## CITY OF NAPOLEON - BUILDING DEPARTMENT

RESIDENTIAL PLAN CORRECTION SHEET

ADDENDUM TO Permit No. 01181  
Owner CARY BREHAD  
Contractor " "  
Location 1415 CLEAVELAND AVE.

Brief Description of Work:----- Building on to existing  
HOUSE, Addition To BE 22' X 35'

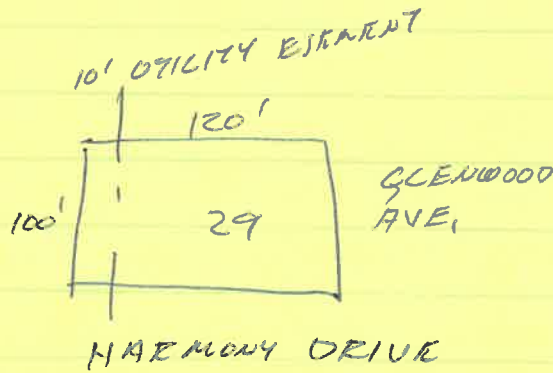
TRUSS DIAGRAM

~~BASEMENT COLUMNS~~

X BEAMS

X HEADER SIZE

EXISTING ELEC. SERVICE EXISTING OR RELOCATED

8'-0" CEILING HT.

TYPE OF LUMBER FOR FLOOR JOISTS

LOCATION +  
 SIZE OF ANY  
 SECONDARY STRUCTURE

SITE PLAN SHOWING

PROVIDE ADEQUATE CLEARANCE TO  
 WALLS TOP 36"  
 FROM SD 12"

? IS PLASTIC VENT OK  
CEILING HT.

IS A NEW ELRC SERVICE REQ. EXISTING

WHAT TYPE OF SHEATHING  
DRYWALL INTERIOR

IS THEIR EXISTING OFF STREET PARKING  
 LOT COURAGE NEW 770

IS THE ELRC SERVICE EXISTING YES
